**Addendum No. 1**

**SUBJECT:** US101: Gold Beach (Rogue River) Bridge Project  
Oregon Coast Highway  
Curry County  
Structure  
(Bids Closing October 17, 2019)

**OREGON DEPARTMENT OF TRANSPORTATION**  
Rogue R\_Hwy 9 (Gold Beach)  
**US101: GOLD BEACH (ROGUE RIVER) BRIDGE PROJECT**  
HIGHWAY 9 (HWY 101) MP 327.51 TO 327.88  
CURRY COUNTY  
Designer: Mats O. Halvardson, PE      Reviewer: Robert E. Grubbs, PE  
Drafter: J. Tilman      Checker: Kelly B. Freeman, PE  
**PLAN AND ELEVATION**      SHEET NO. J01

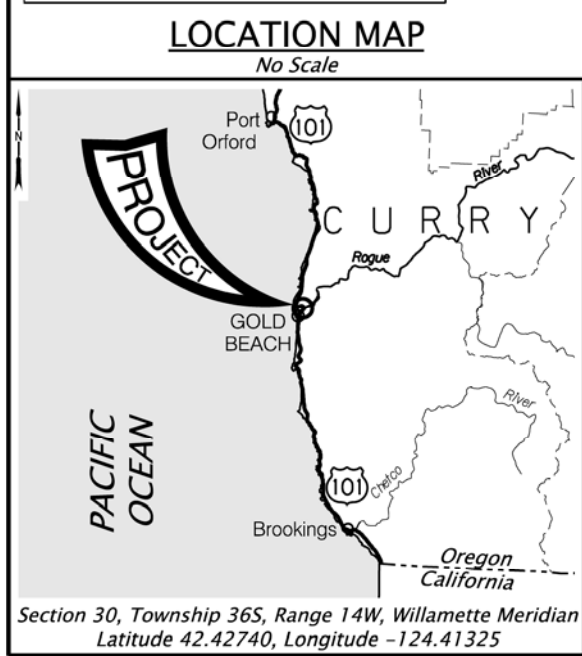
1. Plan sheet J01 is replaced with revised plan sheet J01.

| No. | DATE    | REVISIONS                          | BY  |
|-----|---------|------------------------------------|-----|
| ①   | 2019-10 | Work Item #8 rewritten for clarity | MOH |

- ⑦ Poured joint seal. See special provision 00585 and sheet J08.
  - ⑧ Epoxy inject cracks 0.016 or greater in width on existing exterior Beam A north approach, and Spans N7 and N8 (3 interior beams each span), and Beam K. See special provisions 00538 and 01262 and sheet J08.
